**Environmental Impact Report for the
Kaiser Permanente Moreno Valley Medical Center Project
SCH 2018111051**

MARCH 2020

Figure 1: Outdated Road Network

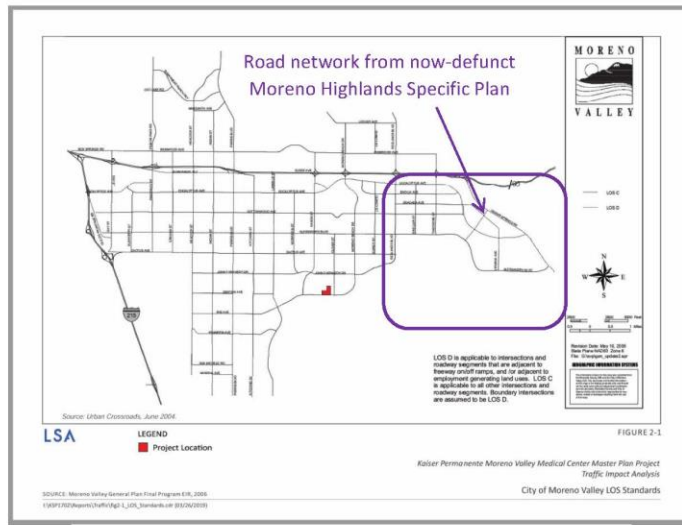
Although we cannot be certain from the report, there are indications that MVTM was, in fact, not properly updated before being used in this study. For example, Figures 2-1 and 4-2 show a road network from the now-defunct Moreno Highlands Specific Plan (see Figures 1 and 2 below). Since the MHSP would have been current when the MVTM was developed it was embedded in the original network in the model. Based on the forecasts shown in Figures 7-1 to 7-15 of the report, it appears that this network was not updated before doing the model runs that are the basis of this analysis.

The comment is correct in noting that TIA Figure 2-1, Figure 4-2 and Figures 7-1 through 7-15 are not fully up to date. These figures are based on the City’s existing General Plan, which is undergoing an update, and these figures do not reflect the current roadway network data. However, the TIA included these figures for general illustration purposes only, and these figures do not constitute or reflect the roadway or other data used in the TIA analysis. As discussed above, the TIA analysis is based on the City’s updated MVTM model, which uses updated roadway data, and is not based on the TIA figures or any data reflected therein. (See Draft EIR, Appendix I (TIA), Appendix A.) TIA Figure 2-1 reflects the City’s currently adopted General Plan Circulation Element LOS standard map and would only be updated when the City prepares an updated Circulation Element Level of Service standard map. Figures 4-2 and 7-1 through 7-15 have been updated with the current roadway configuration and added to the Draft EIR TIA in the form of an errata, as detailed in Chapter 3 of this Final EIR.

Figure 4: Nason/Iris TIA

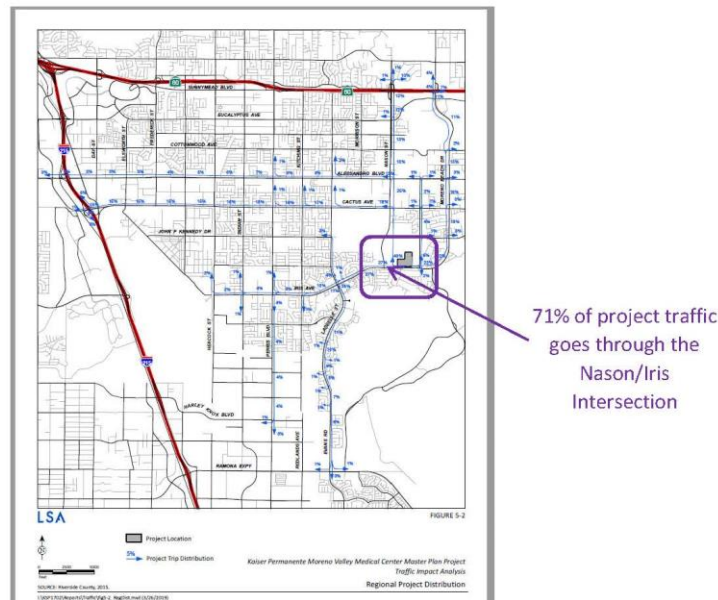
- The main driveway to the hospital (Intersection 63) would have an eastbound queue of vehicles waiting to turn left across Iris Avenue 795 feet long (see Table 8-E). The existing left-turn pocket is only 195 feet long, so they will need both to add a second left-turn lane and lengthen the pocket to prevent operational problems at this location. The queue of vehicles making a southbound left turn out of the hospital would be about 3 times as long as the current pocket, so that will also need to be lengthened.
- 71% of project traffic, over 9 thousand project-related vehicles per day, would pass through the Nason/Iris intersection (see Figure 4 below).

Figure 5: LOS “C”

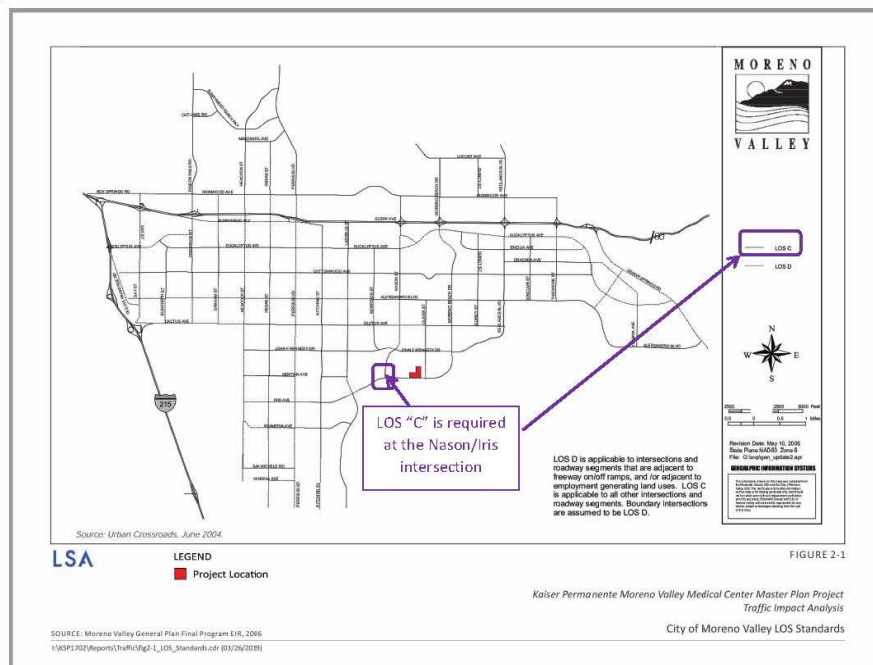
- This is more than 20% of the theoretical capacity of Iris Avenue² between the medical center and Nason Street. This would push Iris Avenue over-capacity and leave Nason Street 97% full³. Also see Figure 5 below indicating LOS C standard for this intersection.
- The intersection would be over-capacity in both the AM and PM peak hours, causing queuing problems there (see Figure 7-13). The project would lengthen the southbound left-turn queue (across Iris and turning towards the hospital) by 520 feet (Table 8-E).

FIGURE 4.9-4
Proposed Drainage

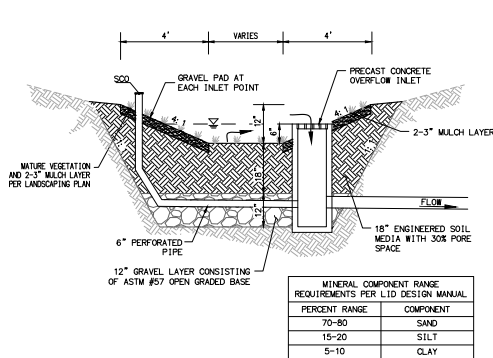
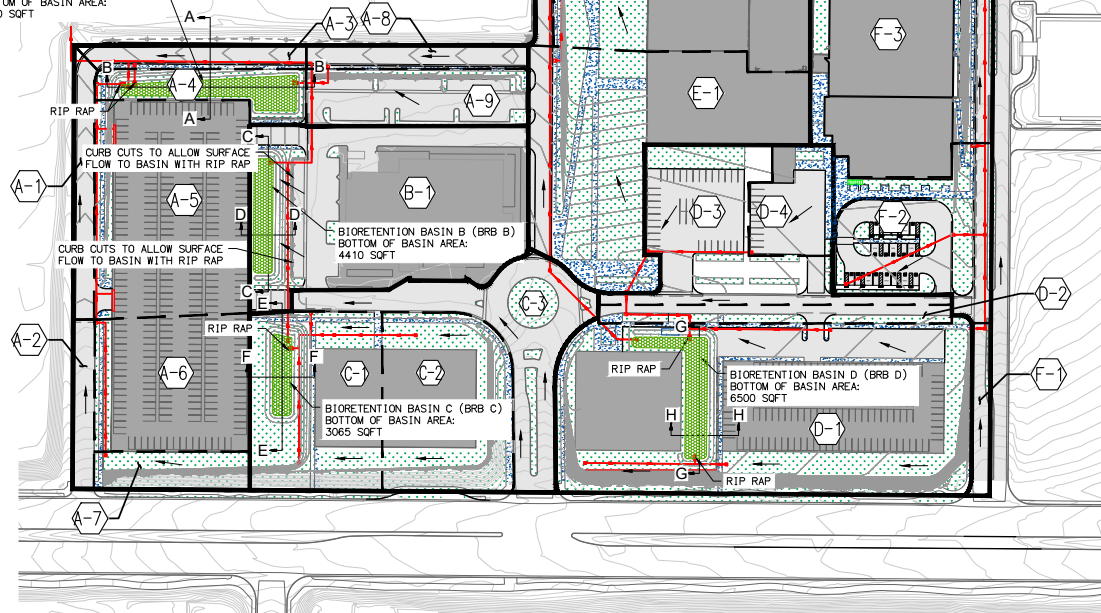
Figure 4.9-4, Proposed Drainage, is replaced as follows.

MM-HYD-2 Treatment control BMP features proposed for the ~~southern~~ western project area, including multiple bioretention ~~sand-filled detention~~ basins (Figure 4.9-4, Proposed Drainage), shall be constructed during Phase II of the project. These treatment control BMPs shall be constructed in accordance with the project Water Quality Management Plan (Appendix G-1) and approved by the City of Moreno Valley.
